**FINAL DRAINAGE REPORT FOR
TAMLIN ROAD RV & BOAT STORAGE**

**January 17, 2020
Project No. 2513400**

**Prepared By:
JR Engineering, LLC
5475 Tech Center Drive, Suite 235
Colorado Springs, CO 80919
719-593-2593**

PCD FILE NO.: PPR1945

Detention Basin Outlet Structure Design

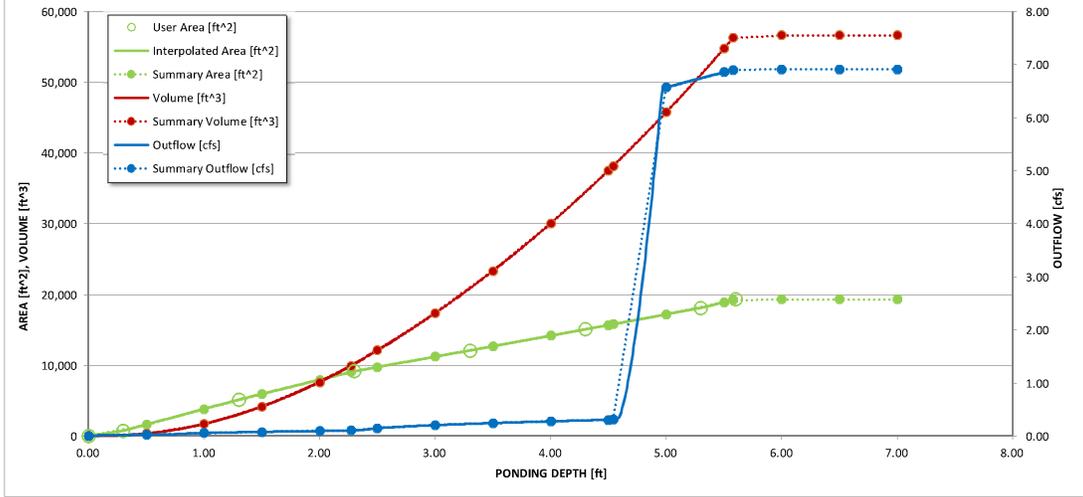
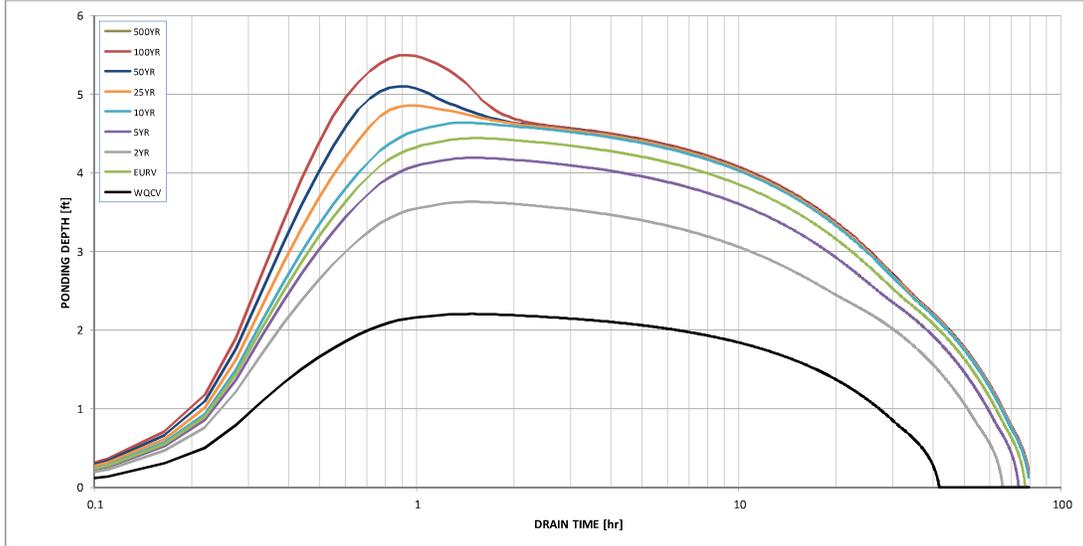
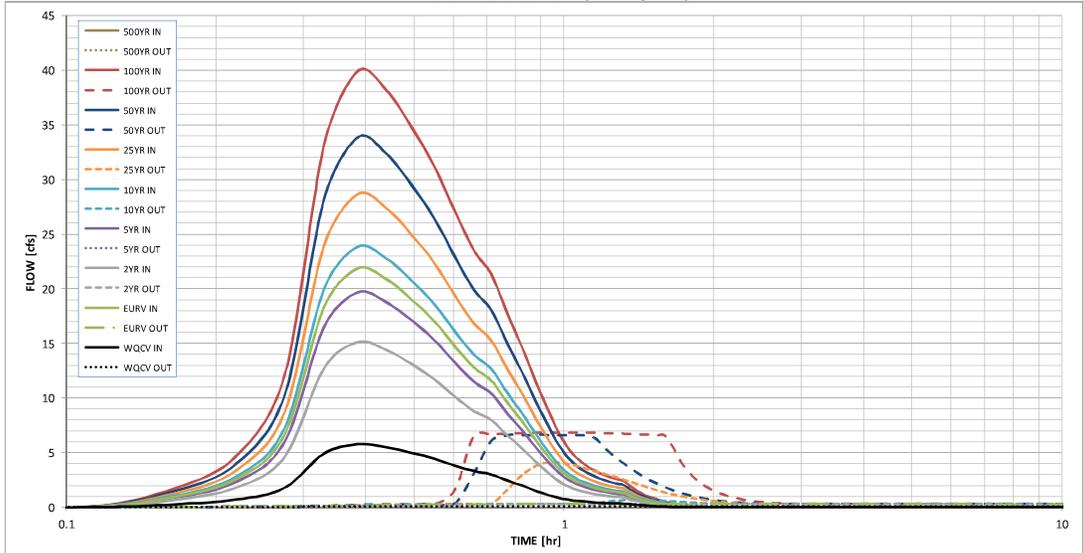
Adjust the design so that the release is equal to or less than pre-development
